LEVEL 00 KEY PLAN

TABLE OF CHANGES FOR PLANNING
AMMENDMENTS: SECTIONS & ELEVATIONS

SUMMARY OF CHANGES BETWEEN CONSENTED PLANNING DRAWINGS, AS PER APPLICATION REF 126648/FO/2020 AND RESUBMITTED PROPOSED MMA APPLICATION DRAWINGS:

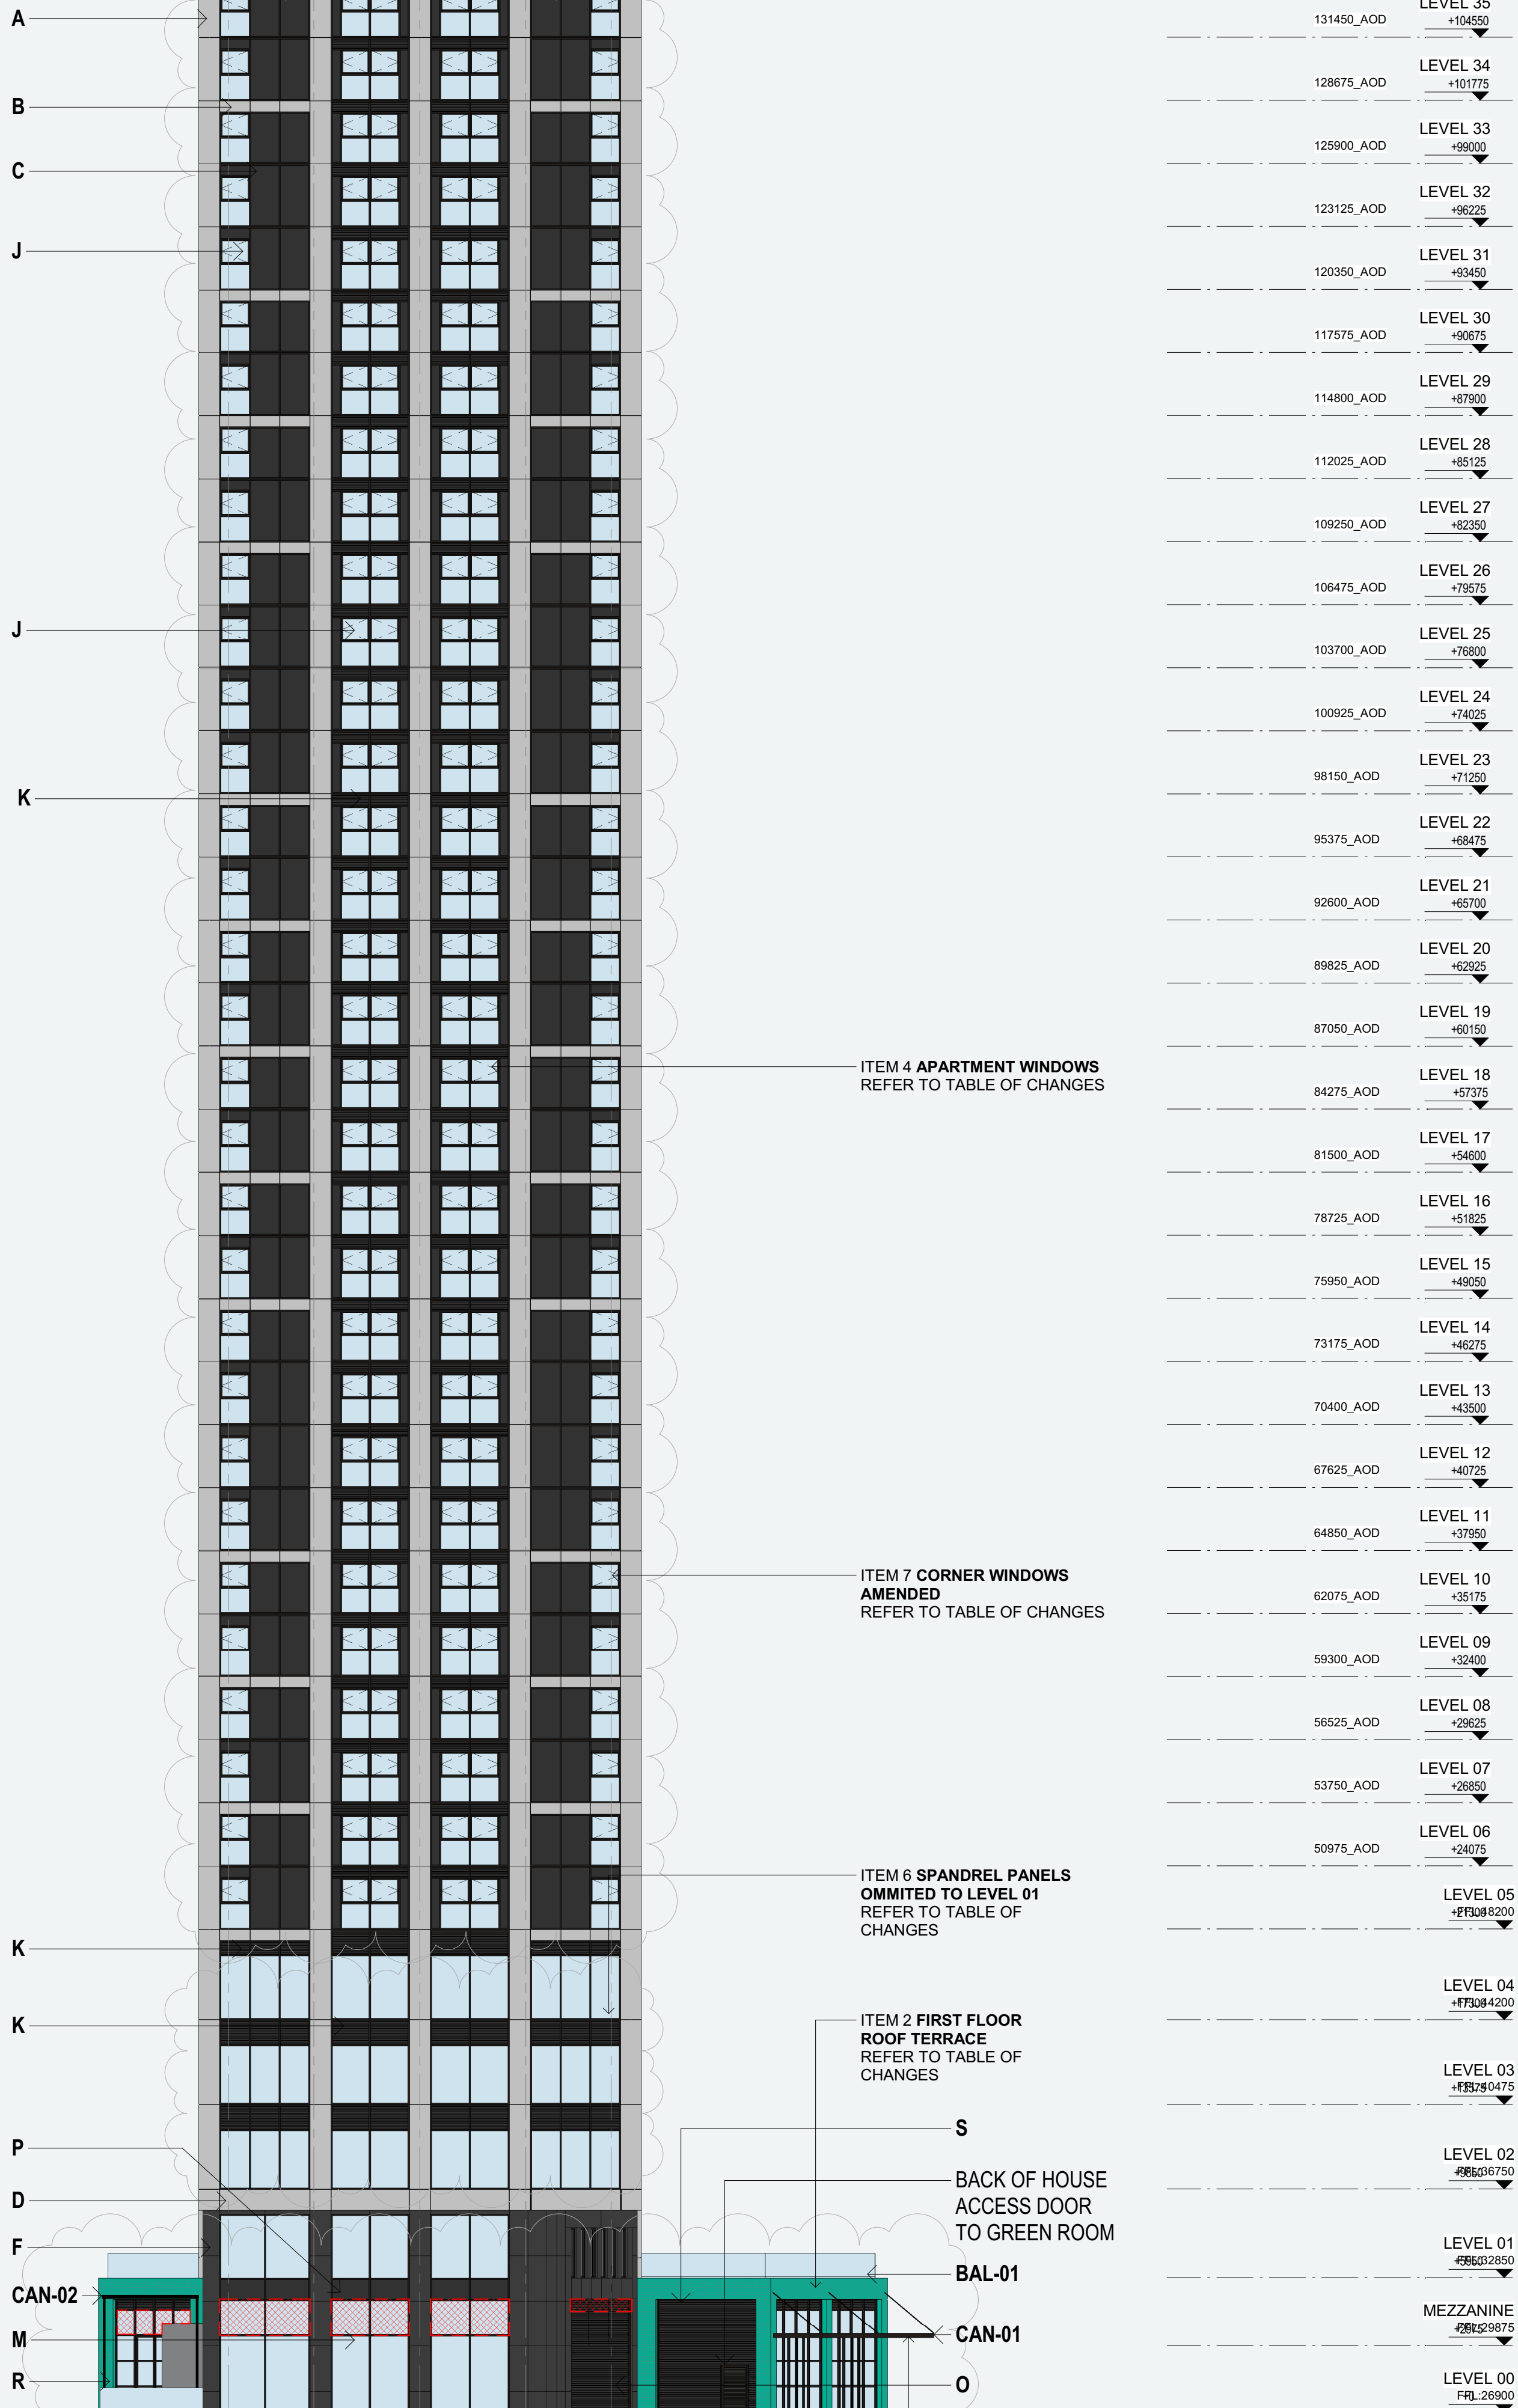
- 1 - GROUND FLOOR COMMERCIAL UNIT**
GROUND FLOOR FOOTPRINT DEVELOPED TO INCLUDE COMMERCIAL UNIT
- 2 - ROOF TERRACE**
INTRODUCED AT LEVEL 01 WITH GLAZED PERIMETER BALUSTRADE

- 3 - CROWN HEIGHT**
HEIGHT OF CROWN REDUCED BY 1.31M
OVEREALL BUILDING HEIGHT REDUCED TO 112M
- 4 - APARTMENT WINDOWS**
SIZE / CONFIGURATION OF APARTMENT WINDOWS TO RESIDENTIAL FLOORS AMENDED

- 5 - BMU AMENDED**
STATIC ROOF-MOUNTED MAINTENANCE UNIT (BMU) AMENDED TO MOBILE PERIMETER TRACK-MOUNTED TYPE BMU WHICH WHEN PARKED IS FULLY CONCEALED
- 6 - SPANDREL PANELS OMITTED AT LEVEL 01-04**
FIXED GLAZED SPANDREL PANELS TO BOTTOM OF LEVEL 01-04 GLAZED SCREENS OMITTED TO NOW MAKE THE SCREENS FULL HEIGHT

- 7 - GABLE FACADE AMENDED**
SIZE AND CONFIGURATION OF WINDOWS FIXED CLEAR GLAZING AND METAL FACADE PANELS AMENDED TO ALIGN WITH SPECIALIST DESIGN ADVICE

- 8 - WIND MITIGATION STRATEGY**
ADDITIONAL TREES, CANOPY, WALKWAY ARCHES, BALUSTRADES AND SCREENS INTRODUCED FOLLOWING WIND MITIGATION ANALYSIS

ITEM 1 GROUND FLOOR COMMERCIAL UNIT
REFER TO TABLE OF CHANGES

ITEM 8 WIND MITIGATION STRATEGY
REFER TO TABLE OF CHANGES

ITEM 4 APARTMENT WINDOWS
REFER TO TABLE OF CHANGES

ITEM 7 CORNER WINDOWS
AMENDED
REFER TO TABLE OF CHANGES

ITEM 6 SPANDREL PANELS
OMMITTED TO LEVEL 01
REFER TO TABLE OF CHANGES

ITEM 2 FIRST FLOOR ROOF TERRACE
REFER TO TABLE OF CHANGES
